DATE: APR 29 1996
REPLY TO:
ATTN OF: WDD:WJT 96-WDD-011
SUBJECT: INDEPENDENT REVIEW OF HANFORD HIGH LEVEL WASTE VOLUME

INDEPENDENT REVIEW TEAM REPORT

OFFICE OF TANK WASTE REMEDIATION SYSTEM (TWRS) HIGH-LEVEL WASTE (HLW) CANISTER
PROJECTION ASSESSMENT AND PROJECT BASELINE GUIDANCE

Figure 1. Projected glass production for various scenarios.

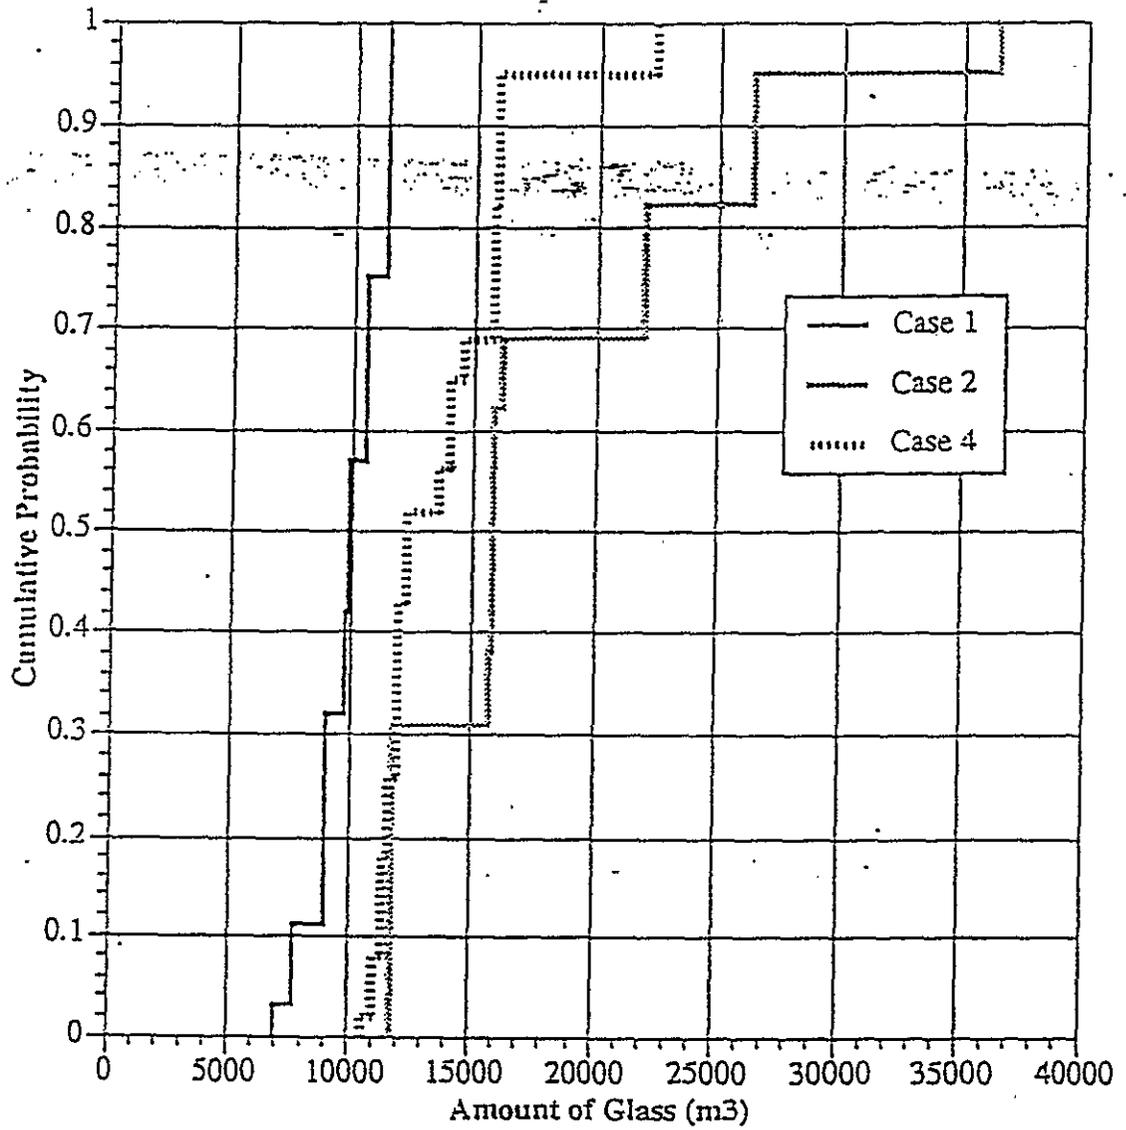
Johnson also looked at the effects of all of the uncertainties, except for blending, on the number of canisters. He allowed each of the various sources of uncertainty to vary between a high, medium and low value, and assigned a probability value 0.25, 0.50, and 0.25, respectively (This approximates a normal distribution about the median value). Using the EIS inventory, he constructed a cumulative distribution function for the amount of glass which would be produced (The number of canisters is this value divided by 0.62). This is shown as Case 1 in Figure 1.

The y-axis shows the probability of producing no more than the amount of glass indicated on the x-axis. As the Figure shows, there is less than a 10 % probability that the number of canisters produced will be less than the 13800 value in the EIS (This corresponds to 8500 m³ of glass). The IRT thus has concluded that this is an appropriate lower bound for use in the EIS.

because it would produce more glass than the EIS inventory, as can be seen in Figure 1 (comparing Case 2 - LANL inventory to Case 1 - EIS inventory). This case used glass processing limits which are somewhat more restrictive than necessary, and thus would produce more glass. To produce an upper bound, the IRT selected the glass production value which corresponds to a 95% probability that it will not be exceeded - 26000 m³. This value was multiplied by the factor of 1.2 obtained from Certa, and converted to canisters by dividing by 0.62. This results in a value of 50000 canisters. Based on this value, the IRT concludes that the 70000 value in the EIS is not only conservative, but overly so. Because the 50000 canister value developed by the IRT reflects the progress made in the last two years, it provides a more appropriate upper bound than the 70000 canister value.

- Improvement of current models for decision-making. It appears that sufficient conservatism has been incorporated into the calculations performed by Johnson (Figure 1), so that the statistical uncertainties in the data have been appropriately addressed. However, an estimate of the standard
